AERONAUTICAL CHARTING MEETING

RECOMMENDATION DOCUMENT

FAA Control # 19-02-344

Subject: Intermediate Segment Stepdown Altitudes

compliance with the intermediate segment stepdown fix altitudes on these approaches is similar to an ILS glideslope, as illustrated by this example - KDFW RNAV(GPS) Rwy 17C:

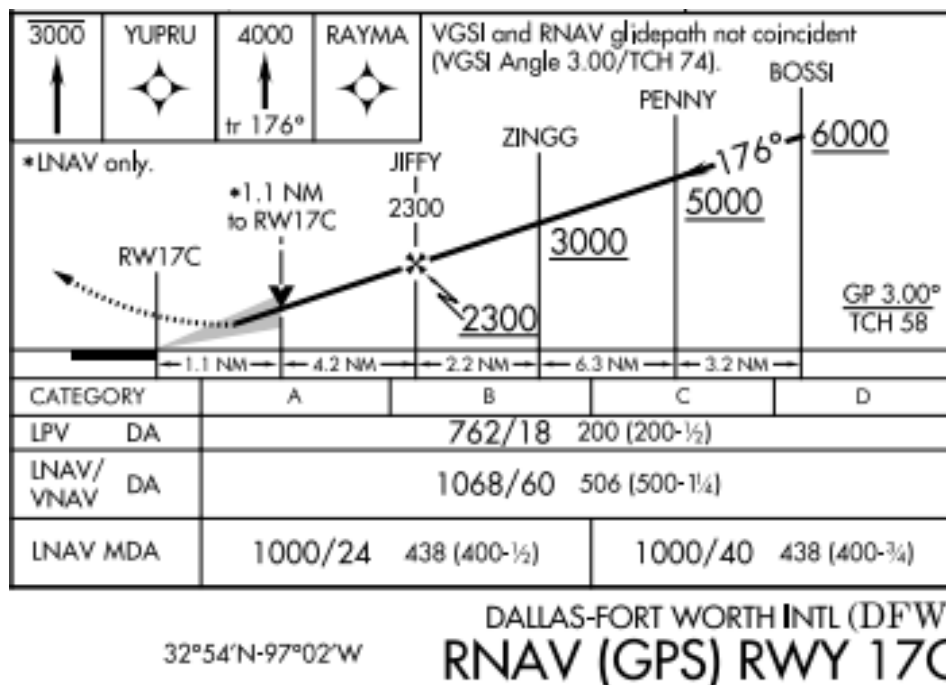
NBAA has recently learned that certain WAAS-SBAS capable RNAV systems will begin using WAAS-SBAS vertical guidance starting at the Final Approach Course Fix (FACF), which is typically, but not always co-located with the intermediate fix (IF) on an RNAV approach. Since the WAAS-SBAS generated vertical path is not subject to hot/cold temperature effects as occurs with a barometric derived (Baro-VNAV) vertical path, the effects of hot temperatures on

- At 100°F, ZINGG is 200' above the WAAS-SBAS glidepath
- At 130°F (charted limit), ZINGG is 300' above WAAS-SBAS glidepath

An aircraft descending using VNAV, which is generated by WAAS/SBAS and not Baro-VNAV, and on the vertical path would cross below the published altitudes at PENNY, ZINGG and JIFFY if BOSSI is designated at the FAF in nav-database coding.

NBAA recommends that the policy memorandum be incorporated into JO 8260.3 U.S. TERPS and on approaches where LPV minima are published, in FAA Order 8260.58.
